Supplement to

Specifications for Electrical Installations

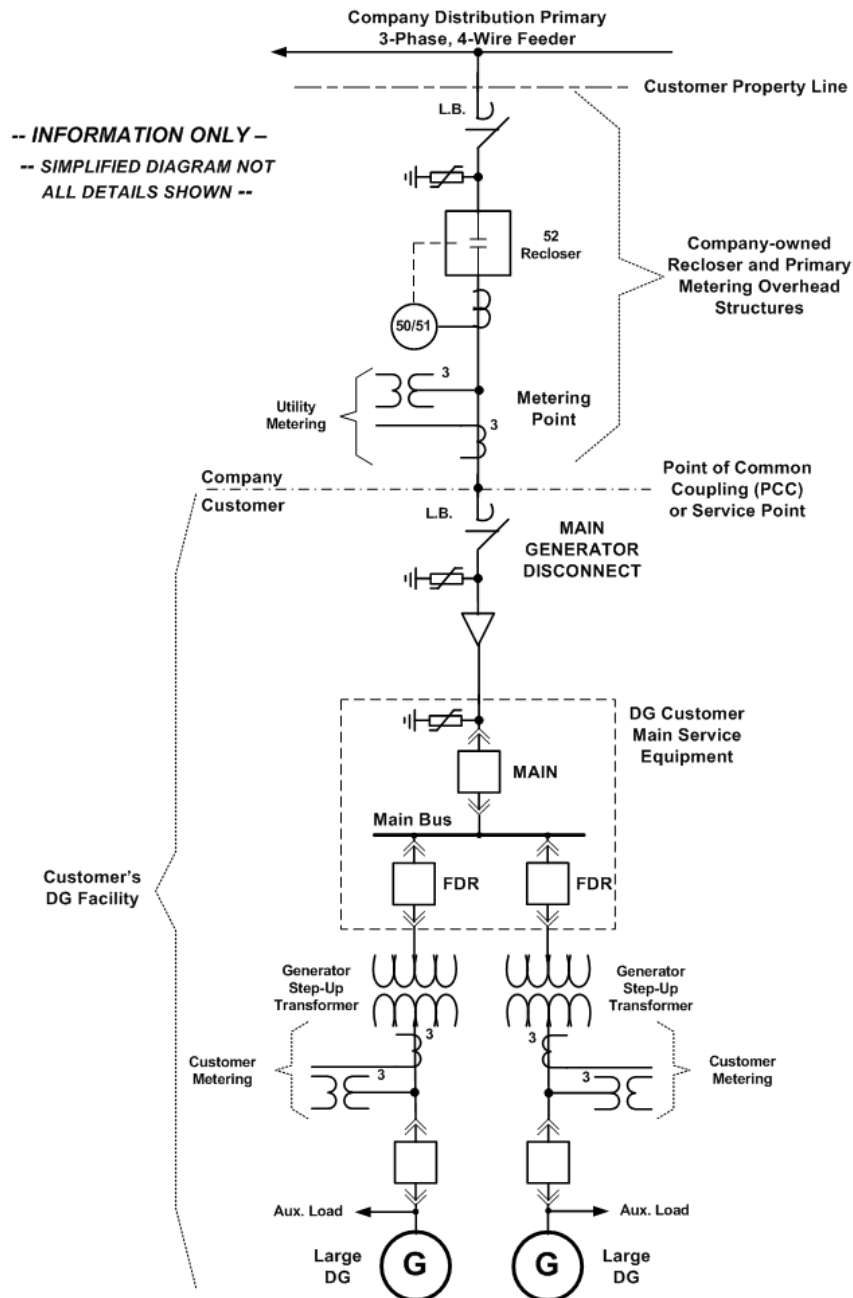
**Electric System Bulletin No. 756 Appendix D:
Distributed Generation Connected to National Grid
Distribution Facilities per the Rhode Island Standards
for Connecting Distributed Generation**
